State of West Virginia  
 Department of Administration  
 Purchasing Division  
 2019 Washington Street East  
 Post Office Box 50130  
 Charleston, WV 25305-0130

NUMBER
GSD136417

Addendum Number: 2

To add a copy of the mandatory pre-bid attendee list, to answer all technical questions submitted in accordance with the provisions of the original solicitation and all issued addenda, and to extend the bid opening date. Bid opening date is extended to 06/26/2013 at 1:30 PM EST.

#### **A. CAISSON LENGTHS**

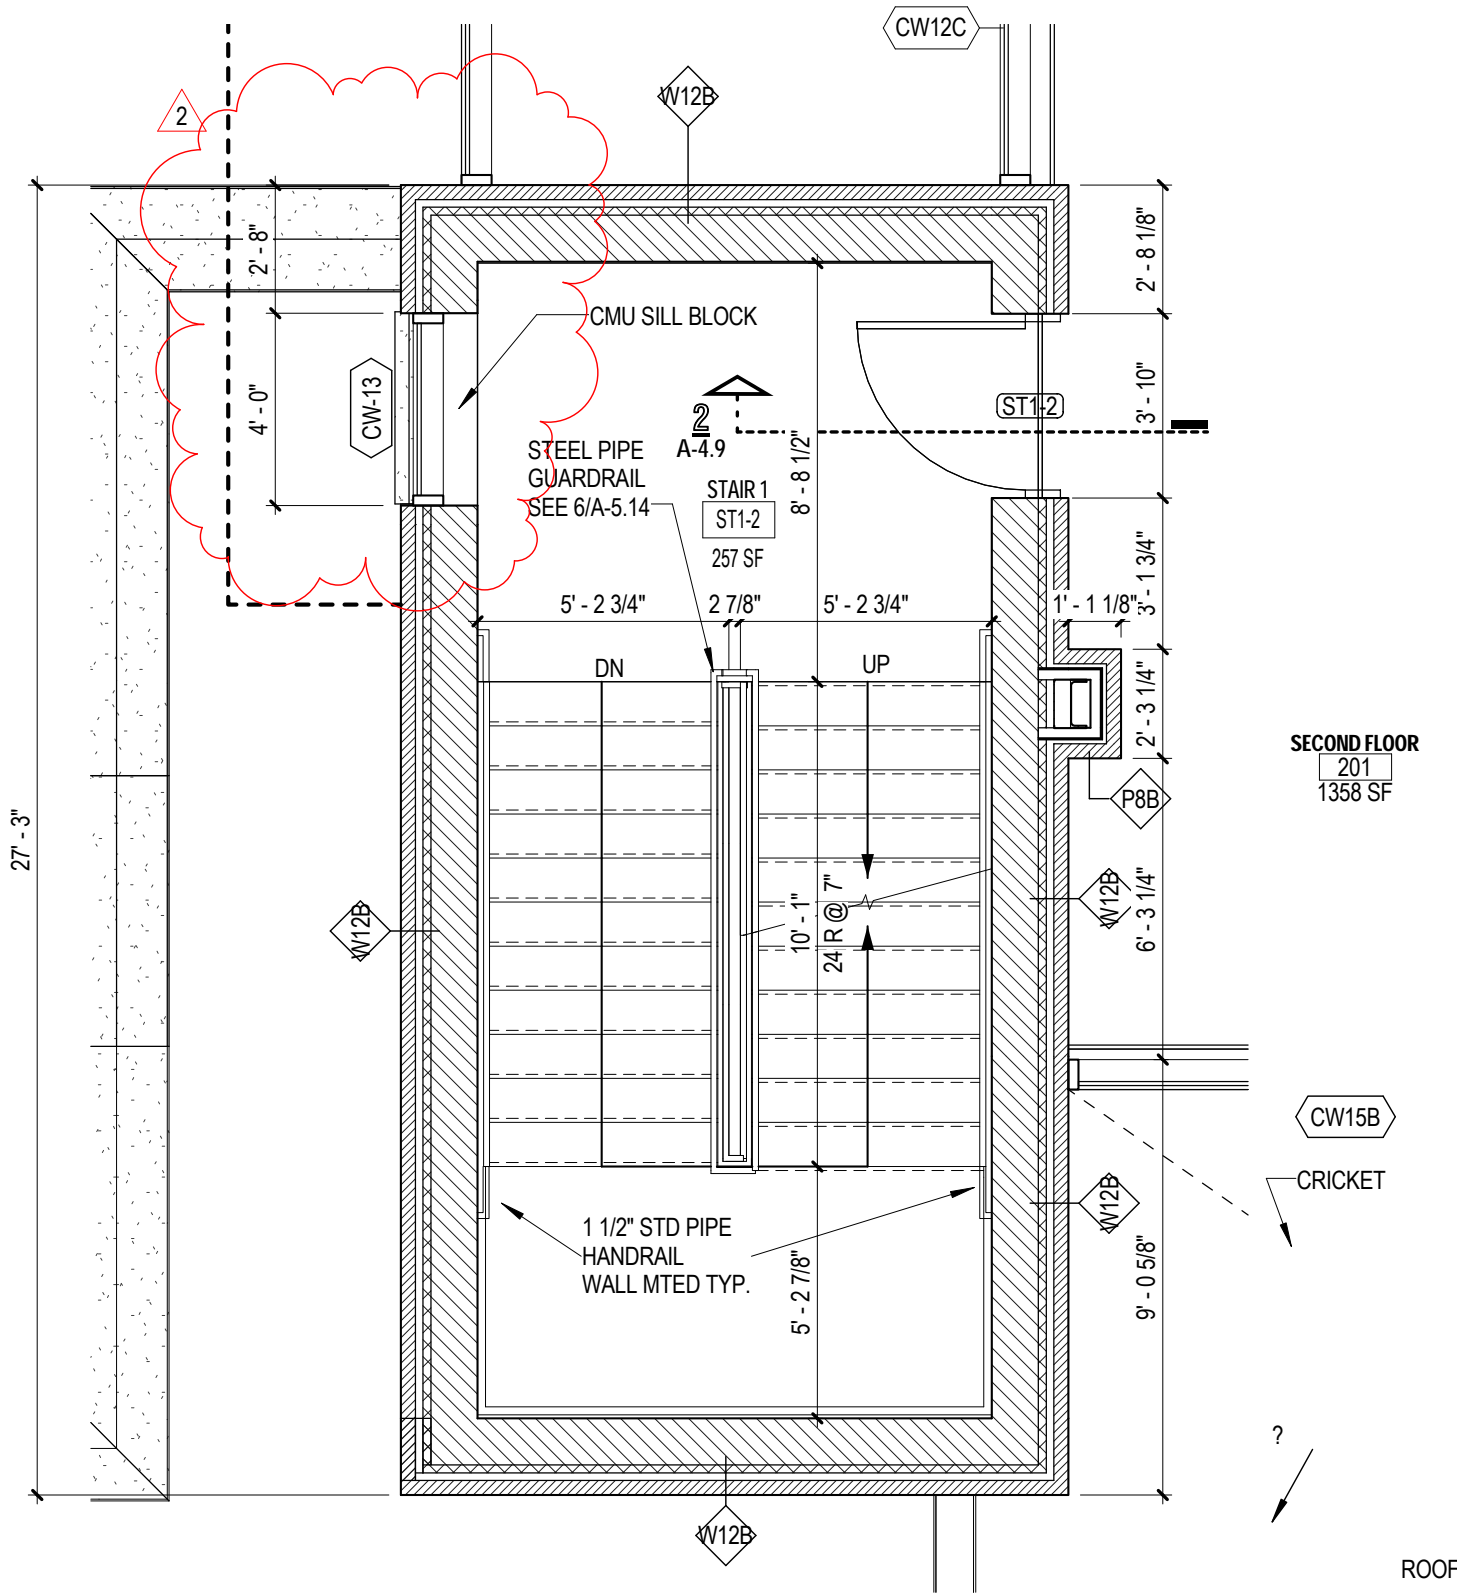
- 1. Deep foundations shall be extended to the competent sandstone. Bedrock consists of competent sandstone with an allowable bearing capacity of 50 tsf. Follow all recommendations made in the Terradon Geotech Report dated August 6, 2010.

NEW STATE OFFICE BUILDING - FAIRMONT  
 PARTIAL SECOND FLOOR PLAN - AREA A - STAIR NO.1

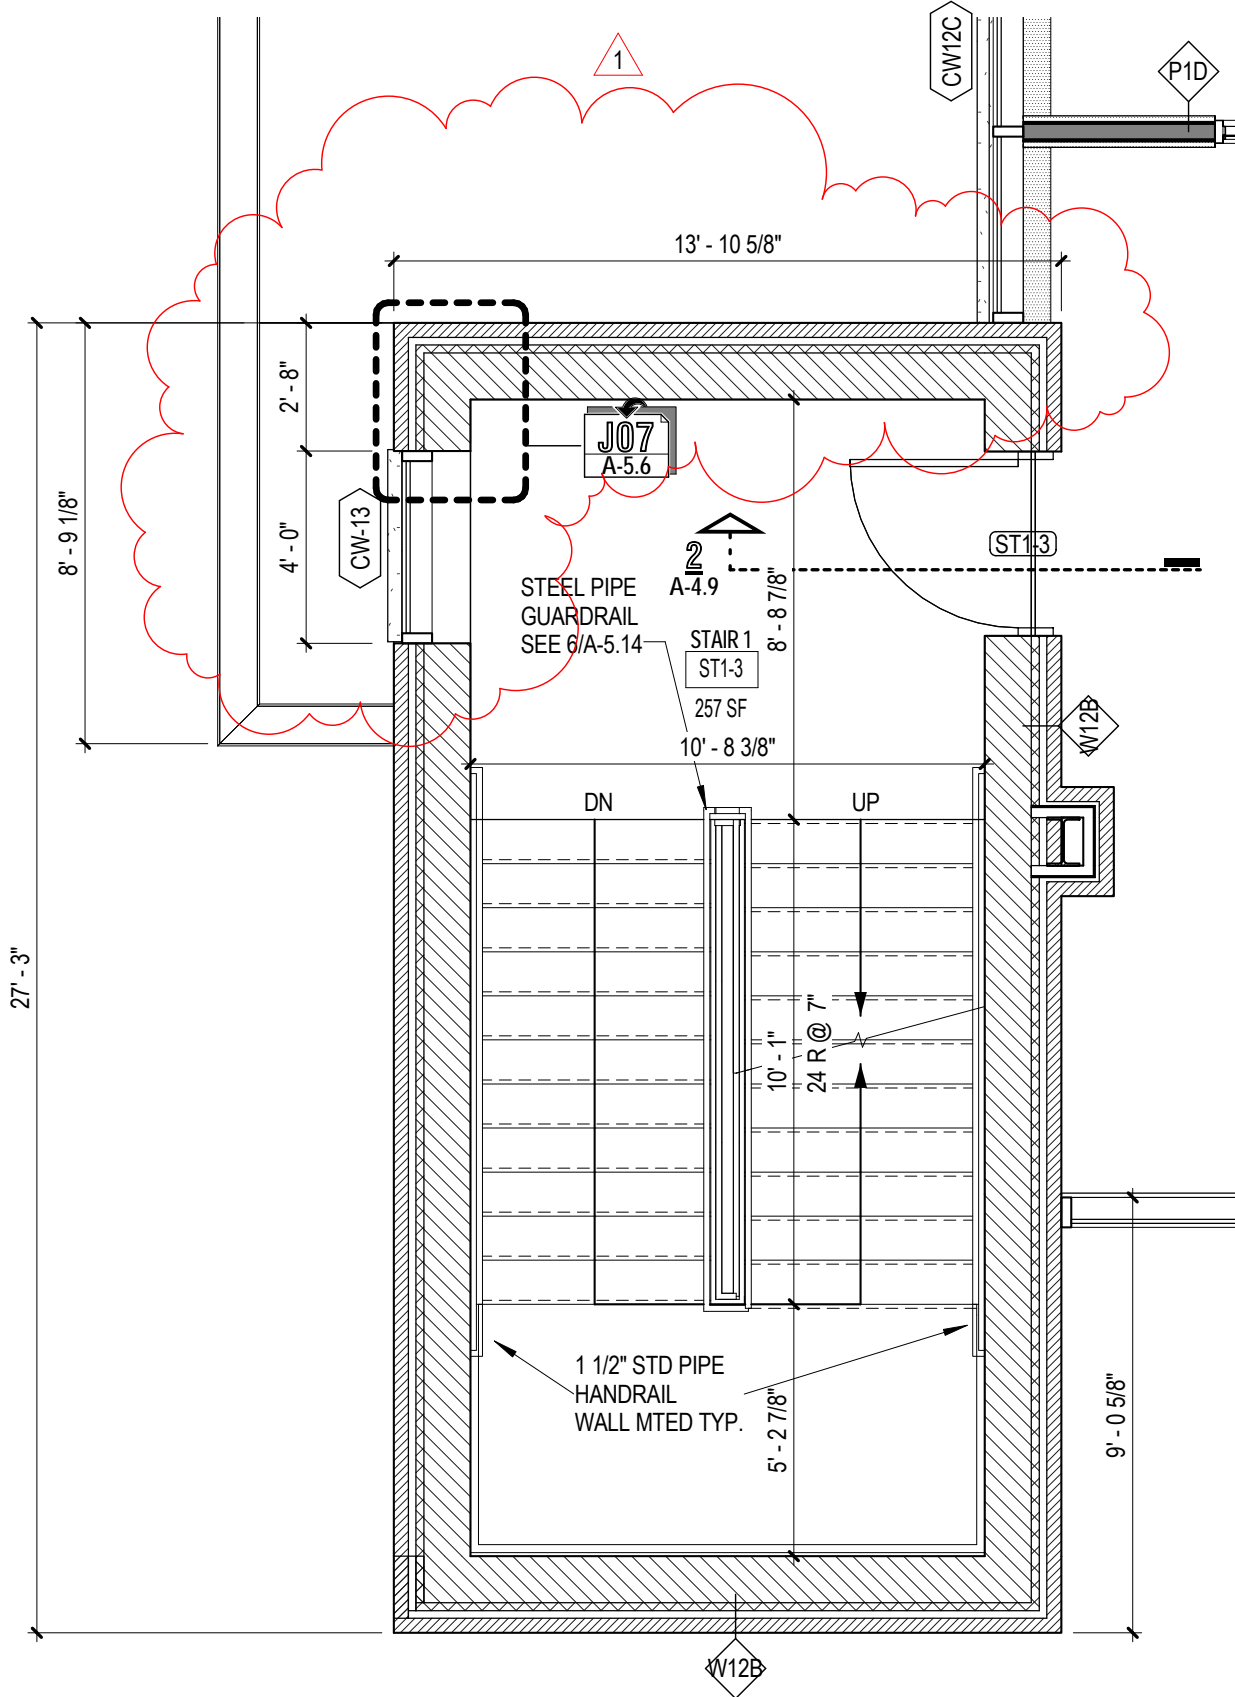
**Addendum 2 – ITEM 11, SHEET A-1.2A SECOND FLOOR PLAN – AREA A**

- A. ADD CW-13 as shown on SK-01 PARTIAL SECOND FLOOR PLAN – AREA A – STAIR NO.1 per **Attachment E**.

NEW STATE OFFICE BUILDING - FAIRMONT  
PARTIAL FIFTH FLOOR PLAN - AREA - STAIR NO.1  
A

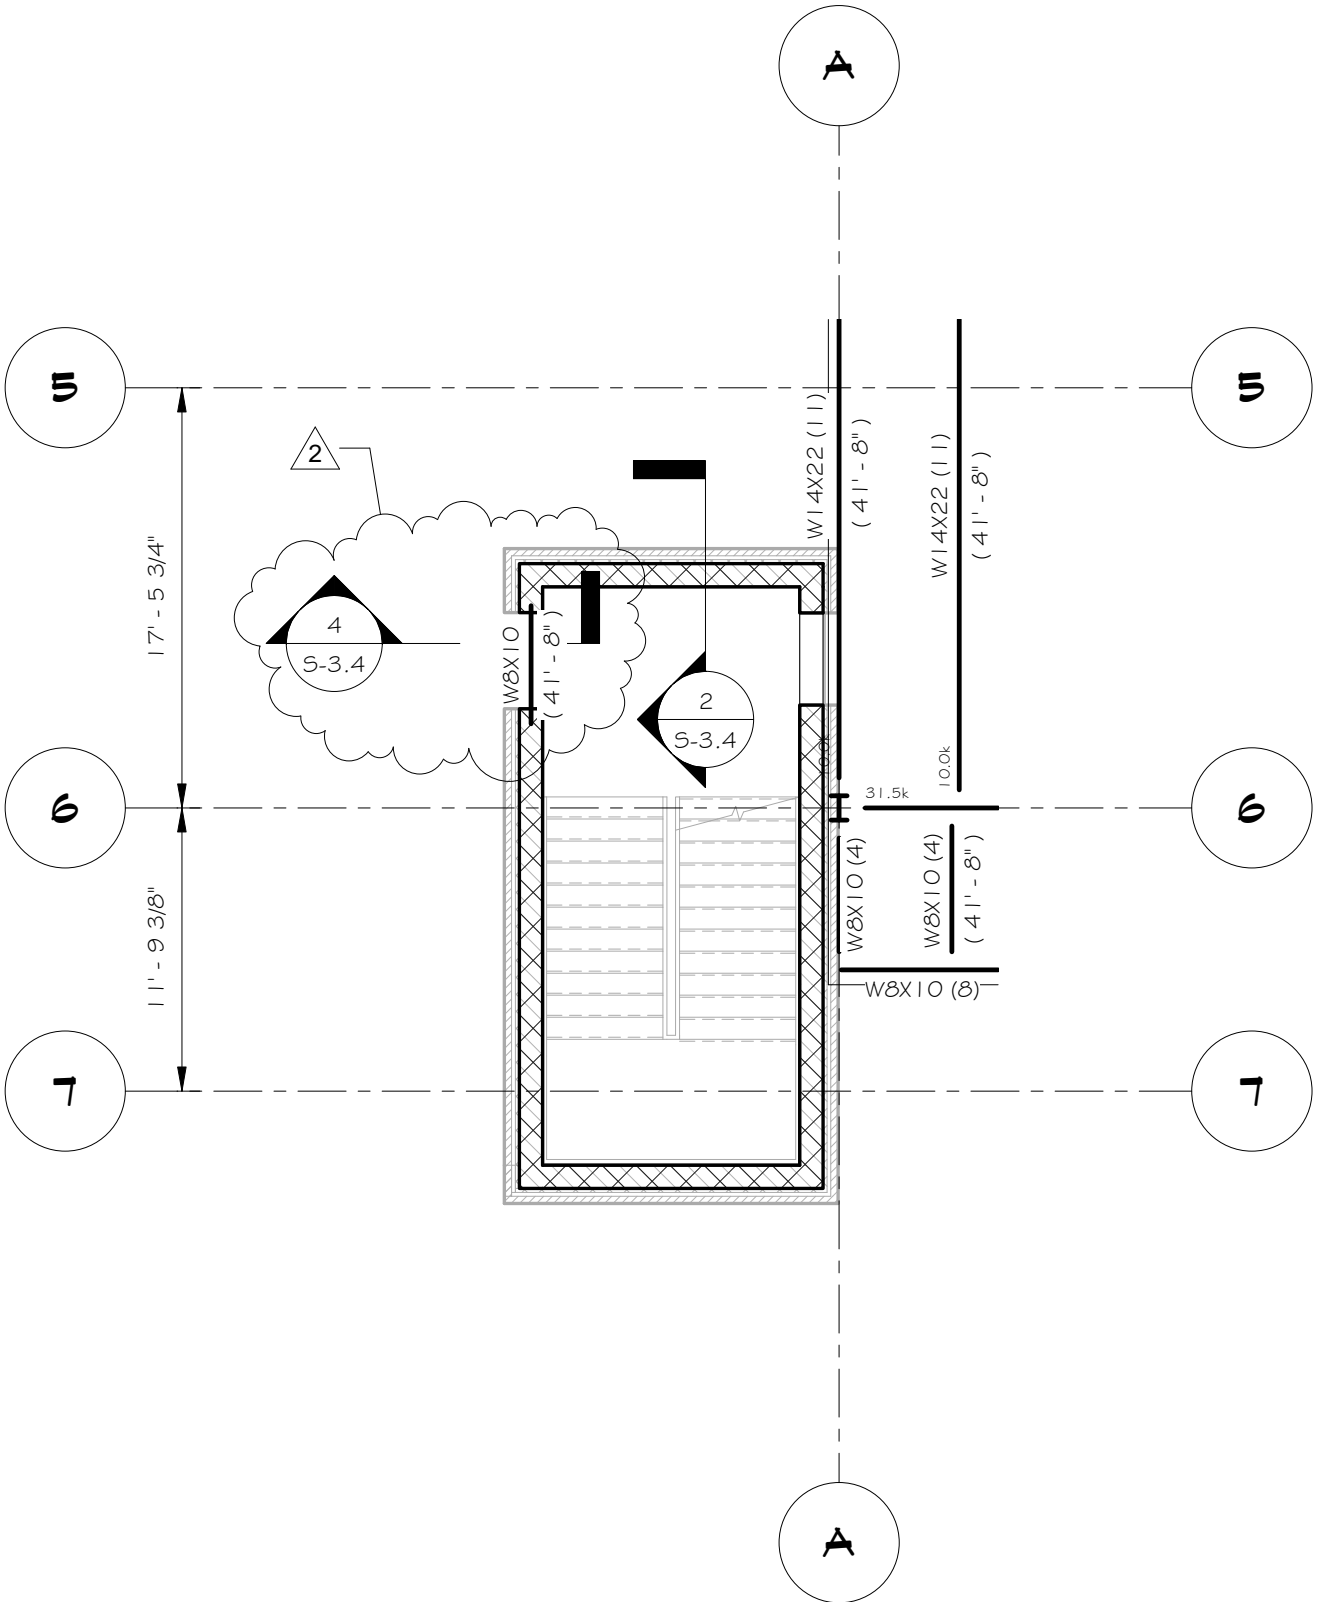
**Addendum 2 – ITEM 14, SHEET A-1.5A FIFTH FLOOR PLAN - AREA A**

- A. REMOVE AND REPLACE CW-13 as shown on SK-04 PARTIAL FIFTH FLOOR PLAN – AREA A – STAIR NO.1 per **Attachment H**.

SK-1

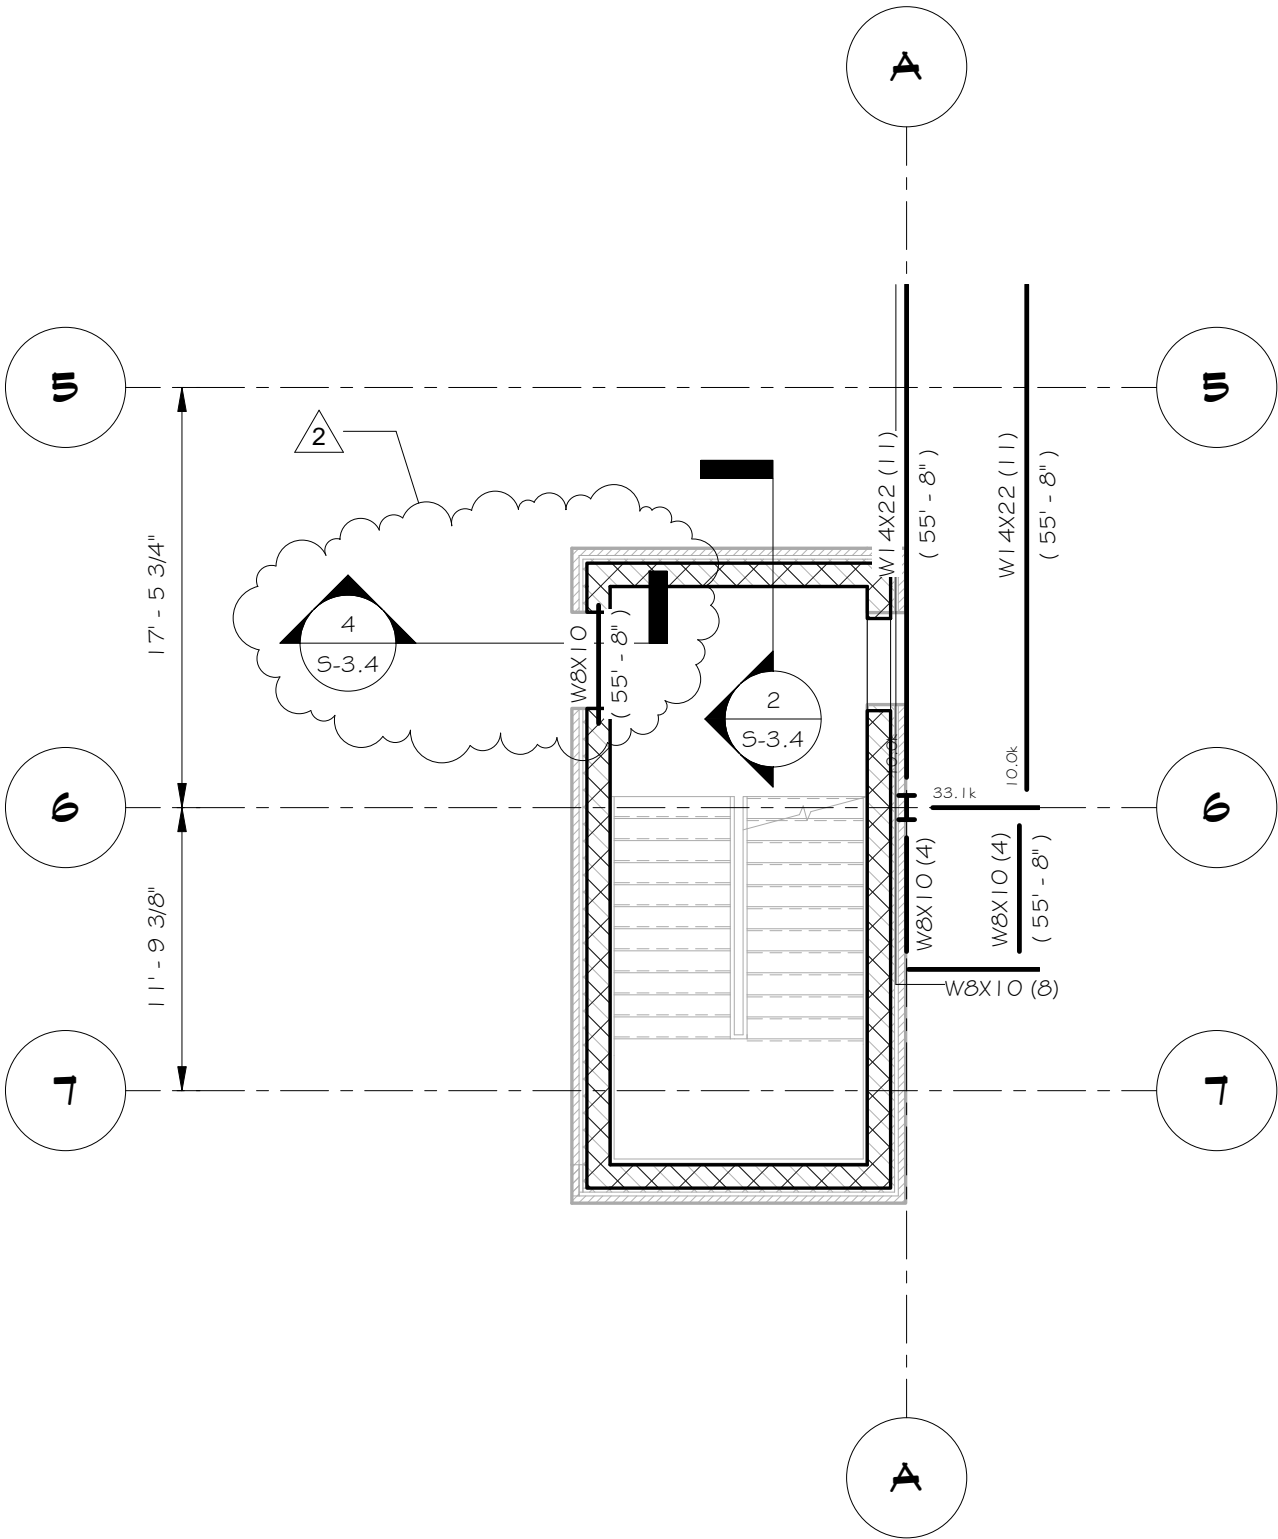
**Addendum 2 – ITEM 25, SHEET S-2.4 FOURTH FLOOR FRAMING PLAN**

- A. ADD SK-1 PARTIAL FOURTH FLOOR PLAN per **Attachment J**

NEW STATE OFFICE BUILDING - FAIRMONT  
PARTIAL FIFTH FLOOR PLAN

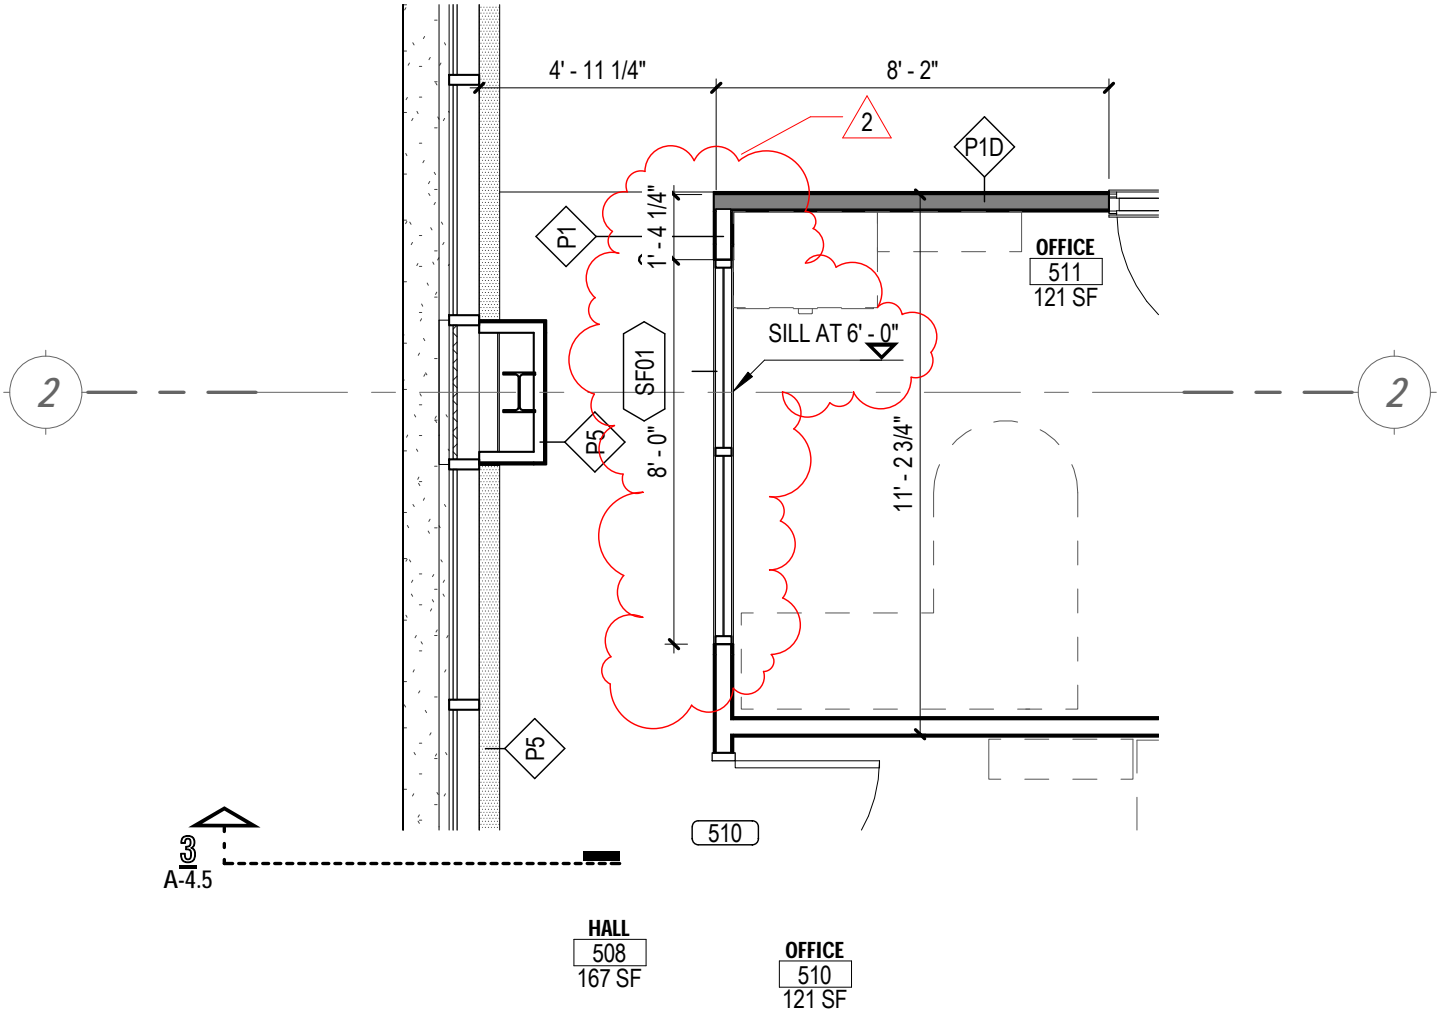
**Addendum 2 – ITEM 26, SHEET S-2.5 FIFTH FLOOR FRAMING PLAN**

- A. ADD SK-2 PARTIAL FIFTH FLOOR PLAN per **Attachment K**.

NEW STATE OFFICE BUILDING - FAIRMONT  
TRANSOM AT OFFICE 511

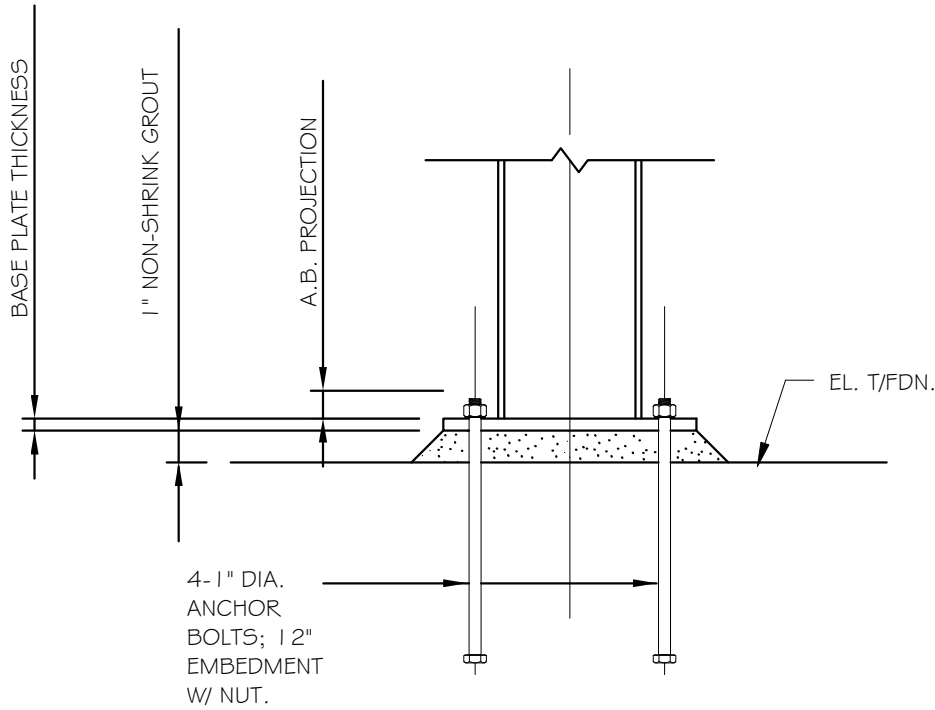
**Addendum 2 – ITEM 15, SHEET A-1.5A FIFTH FLOOR PLAN – AREA A**

- A. At Office 511, West Wall, mark the transom shown as Type SF01 and provide dimensions per **Attachment L**.
